Our Case Number: ABP-316272-23

Re: Bus Connects Templeogue/Rathfarnham to City Centre Core Bus Corridor Scheme
Templeogue/Rathfarnham to City Centre

**BusConnects Templeogue / Rathfarnham to City Centre CBC proposals and planning application
Impact on Rathfarnham Castle Park & Rathfarnham Village Green Space Ref: 316272**

**BusConnects Dublin Templeogue / Rathfarnham to City Centre CBC
Submission on Planning Application in relation to the Proposed Scheme
Objection to proposed Compulsory Purchase Orders
Rathfarnham Castle Park
Entrance to Rathfarnham Wood Estate**

Close up view of Fig 13.1 – Surfacewater study area – showing no watercourse marked beside RCP although it is an open watercourse just inside the RCP wall where it will be directly built over. This is despite the fact that the maps at Fig 14.5 and Fig 14.13 clearly show the Glin River and duck pond.

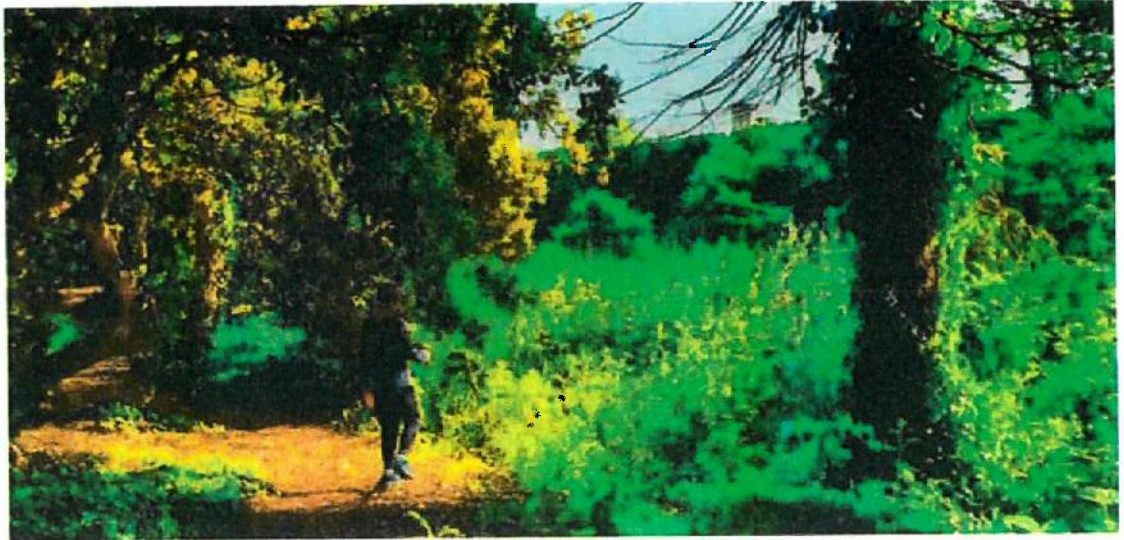
Yet when it comes to the actual environmental study areas, the Glin River and duck pond are not included. They have clearly not been evaluated or even considered. We cannot understand this glaring omission and clear breach of the Water Framework Directive.

Image 2.14 from Chapter 2 of the EIA showing minimal impact from Grange Road to Rathfarnham Road / Fergus Road:

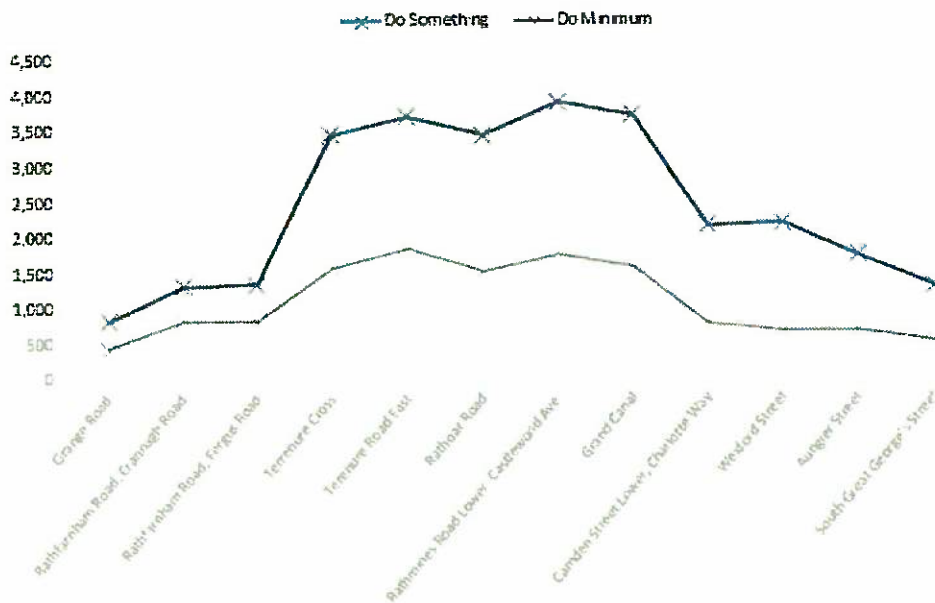
The projections show that the proposed reductions in journey time due to BusConnects will be minimal. Image 2.14 in Chapter 2 of the EIAR shows that the BusConnects scheme would have a far lesser impact around Rathfarnham than it would at other areas in any event.

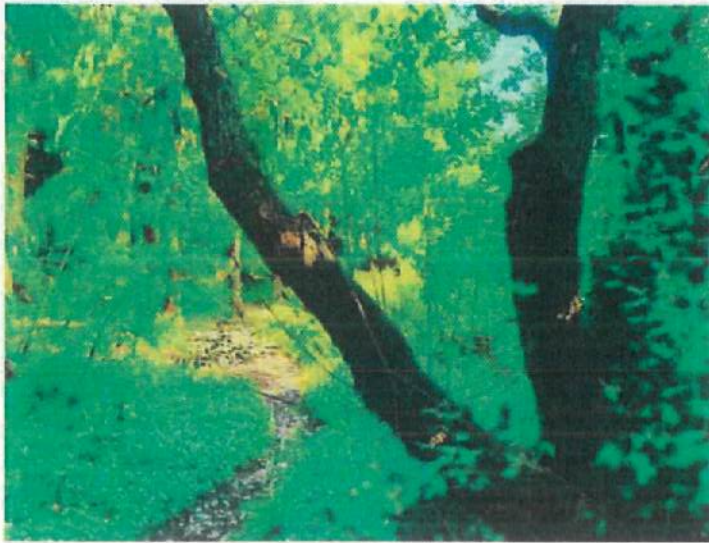
10.4.4.1.1. states that: *“The following amenity designations are also expected to experience the following a Negative, Significant and Short-Term impact during the Operational Phase of the Proposed Scheme:*

This is simply wrong - the impact on Rathfarnham Castle Demesne’s Woodland area will not be short term.

Fig 12.1.3. - Ecological Study Areas: Aquatic and Riparian Survey Site:

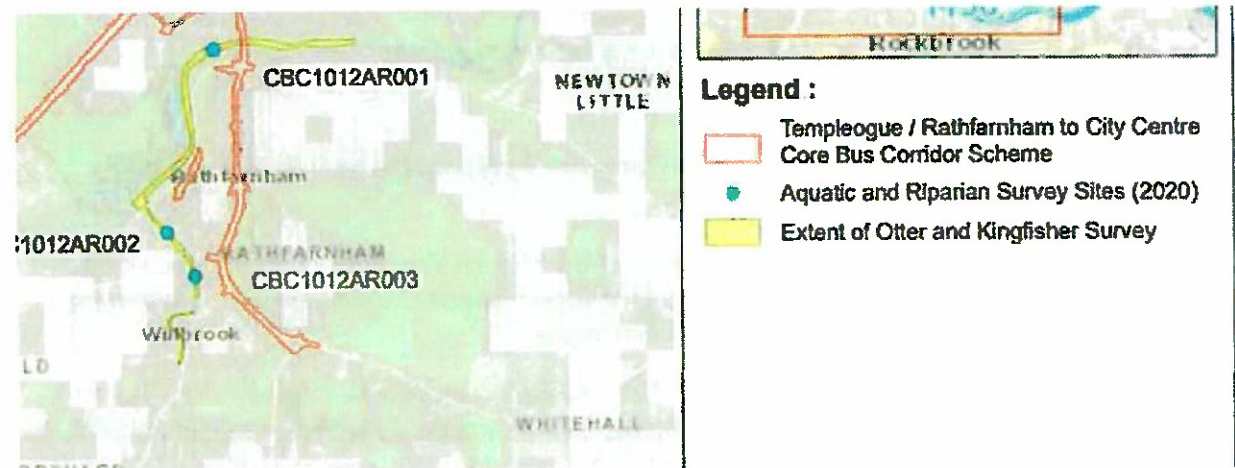
It is clear that neither the Glin River nor the pond were surveyed for otters or kingfishers. This is despite the fact that a kingfisher has been spotted in the Park, most recently on 23/7/23 and the Glin River / Whitechurch Stream is a known otter habitat.

Fig 12.1.2 Ecological Study Areas: Wintering Bird Transect Route – RCP was not studied:

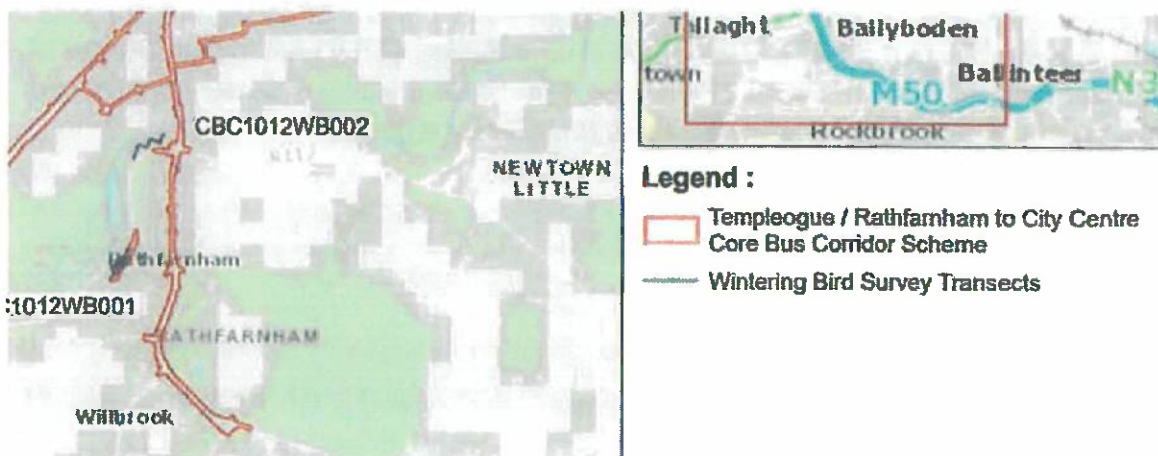
This omission can also be seen from Fig 12.1.2 Ecological Study Areas: Wintering Bird Transect Route - the wintering bird survey transects did not include RCP.

Image 07 in Appendix 14.1 notes the presence of an apparently “dry” stream close to Butterfield Avenue (it is an active watercourse) yet completely fails to consider that there is a pond in the Park and a water source, the River Glin, constantly feeding and draining that pond!

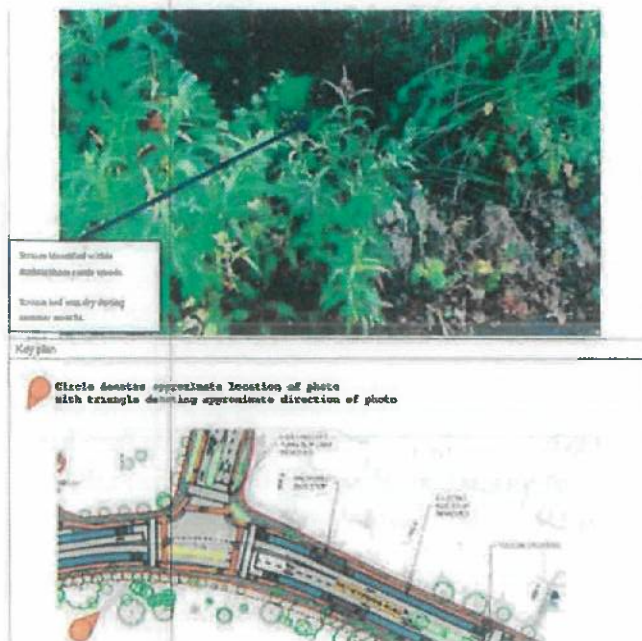
However it can be seen from the above table that the only stream in RCP identified in this survey was thought to be running “adjacent to the proposed bus corridor”, not actually under the corridor at two locations. See below indicator from Image 07 of where the photo was taken, close to Butterfield Avenue:
